To: Development Review Board  
From: Mary O'Neil, AICP, Principal Planner  
Date: Wednesday, March 3, 2021  
RE: 75 Cherry Street; ZP21-0414CA

**File:** 21-0414CA; Amendment to ZP17-0662CA/MA

**Location:** 75 Cherry Street (Burlington City Place)

**Request:** Amendment to ZP17-0662CA/MA; redevelopment of the former Burlington Town Center Mall site into 700,000 sf mixed use. 426 residential units, restaurant, retail, community space, co-working and meeting space. Includes 422 parking spaces in structured garage.

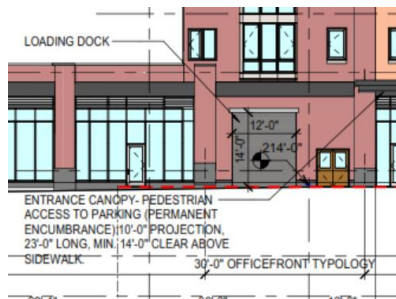
The Bank Street loading dock was previously approved under 17-0662CA/MA as two openings, each 20'6" wide. The Bank Street loading dock may therefore be permitted up to that width.

St. Paul Street loading dock

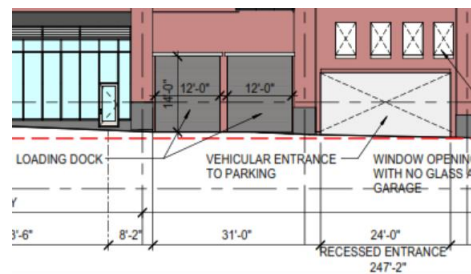
The applicants have asserted they **no longer have a need** for any Alternative Compliance relative to the proposed loading docks on St Paul and Pine Streets. Not applicable.

Pine Street parking access, detail.

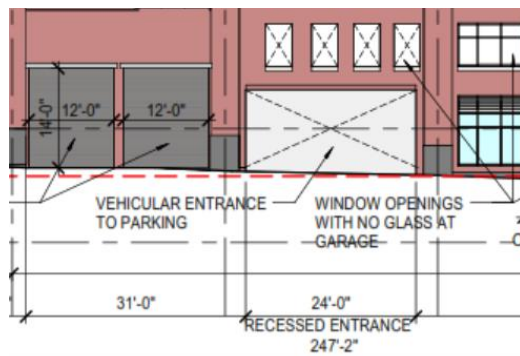
Although the plan set illustrates parking entries to be 24' in width, the applicant acknowledges that it may not be functionally possible. The two newly established streets (St. Paul, Pine) are quite narrow, and the Parking flow study for parking volumes in conjunction with the traffic study test the width limitation. A 20% maximum relief would offer an additional 4.8' width allowance or a maximum of **28' 9 19/32"**.

The Design Advisory Board acknowledged the challenge of creating a two-way vehicular opening that would accommodate a segregated pedestrian walkway, a parking booth and mechanical entry arm within the confines of the 24' limitation, and have supported the requested relief. **Affirmative finding upon concurrence of the DRB.**
